Well Name: HEGEMON WC FEDERAL COM	Well Location: T26S / R29E / SEC 28 / NWNW /	County or Parish/State:
Well Number: 701H	Type of Well: CONVENTIONAL GAS WELL	Allottee or Tribe Name:
Lease Number: NMNM138837	Unit or CA Name:	Unit or CA Number:
US Well Number: 3001553937	Well Status: Approved Application for Permit to Drill	Operator: MARATHON OIL PERMIAN LLC

Type of Action: APD Change

Procedure Description: Marathon Oil Permian respectfully request approval for an APD change for the Hegemon 21 WD Fed #31H as shown below and on the attached: Well Name change to: Hegemon WC Federal Com #701H Change TVD: 10100' Cement variance request SHL & BHL changes: Approved: SHL: 675' FNL & 665' FWL, Sec. 28, BHL: 330' FNL & 330' FWL, Sec. 21. Proposed: SHL: 267' FNL & 660' FWL, Sec 28, BHL: 330' FNL & 1980' FWL, Sec. 21 Change to Casing Design: Change from 4 string to 3 string design. Approved Csg design: Surf, 13.375 set @ 370' Int I, 9.625" set @ 2700' Int II, 7" set @ 10040' Prod, 4.5" liner set @ 9740-15261' Proposed casing design: Surf, 13.375 set @ 553' Int, 9.625" set @ 9302' Prod, 5.5" set @ 21159' Please see attached drill plan for cement design changes, and directional plan. Please see

WELL LOCATION AND ACREAGE DEDICATION PLAT

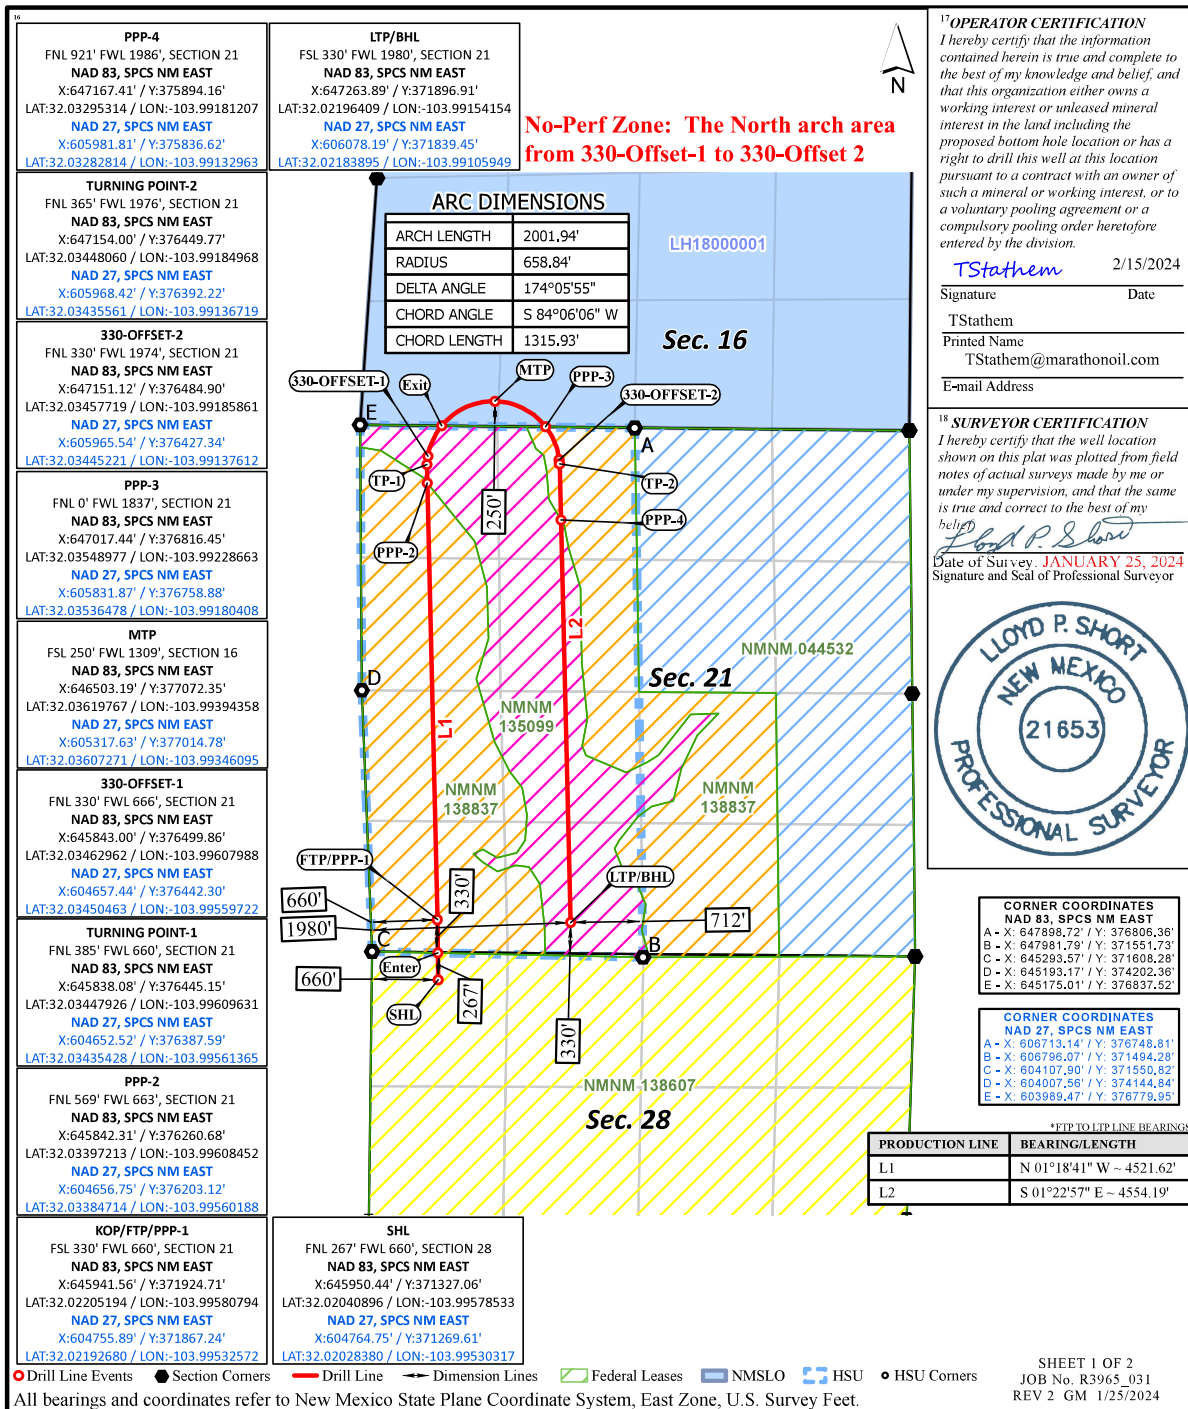
SHL & BHL changes:

Approved: SHL: 675' FNL & 665' FWL, Sec. 28, BHL: 330' FNL& 330' FWL, Sec. 21.

Proposed: SHL: 267' FNL & 660' FWL, Sec 28, BHL: 330' FNL & 1980' FWL, Sec. 21

Please see attached drill plan for cement design changes, and directional plan. Please see C102 for drill plans and No Perf Zone.
NO new disturbance request. Well pad approved 550' X 750 no change.

UL or lot no.	Section	Township	Range	Lot Idn	Feet from the	North/South line	Feet from the	East/West line	County
D	28	26S	29E		267'	NORTH	660'	WEST	EDDY

UL or lot no.	Section	Township	Range	Lot Idn	Feet from the	North/South line	Feet from the	East/West line	County
N	21	26S	29E		330'	SOUTH	1980'	WEST	EDDY
¹² Dedicated Acres 320.00	¹³ Joint or Infill	¹⁴ Consolidation Code	¹⁵ Order No.
